Addendum No.: 3

Date Of Addendum: 4/15/2026

**Underground Storage Tank Replacement at Harwinton Consolidated School
115 Litchfield Road, Harwinton, CT 06791
State Project 210-0037CVOT**

M-101

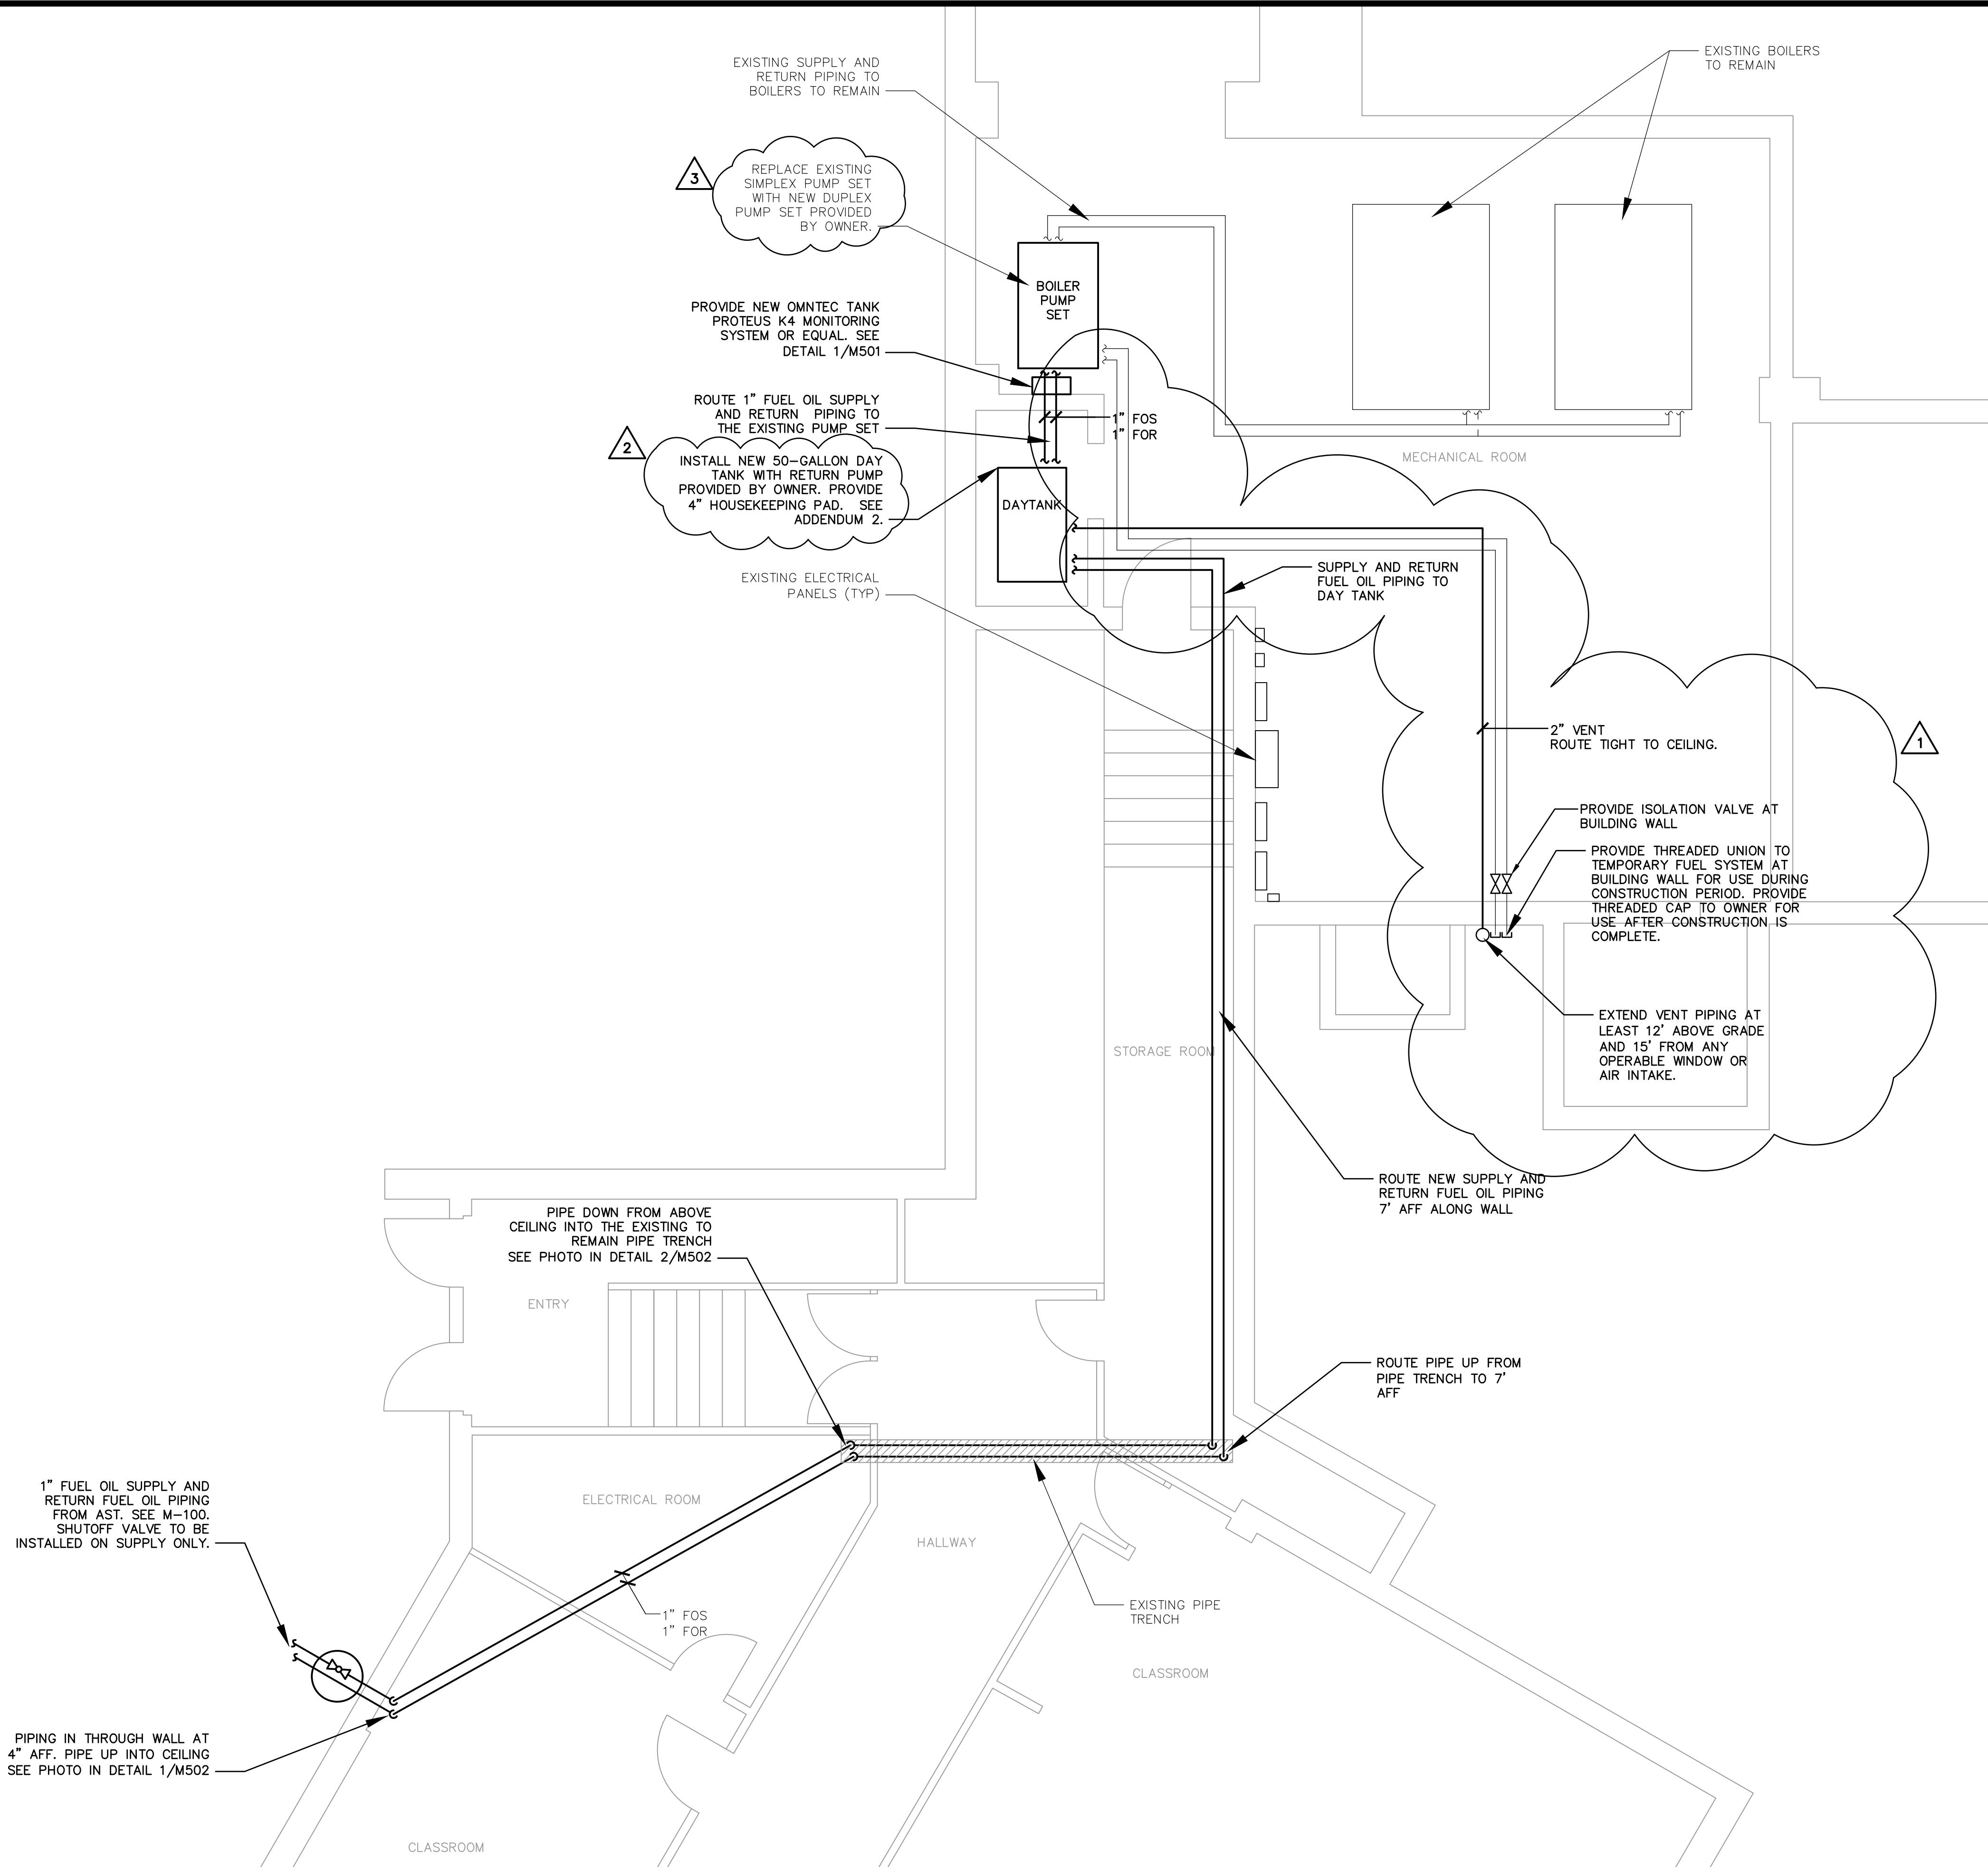
Scope Change: Due to extended lead times, RSD-10 intends to purchase the alternate bid daytank with return pumpset, as well as the replacement duplex boiler pump set from Pryco prior to issuing a contract with the selected contractor. Attached are the quotes from Pryco indicating parts included with this equipment (these attachments are the same as Addendum 2). Installation, startup will be by the Contractor. Contractor to provide 4" housekeeping pad for new daytank.

See updated drawings M-101, M-501 and M-502.
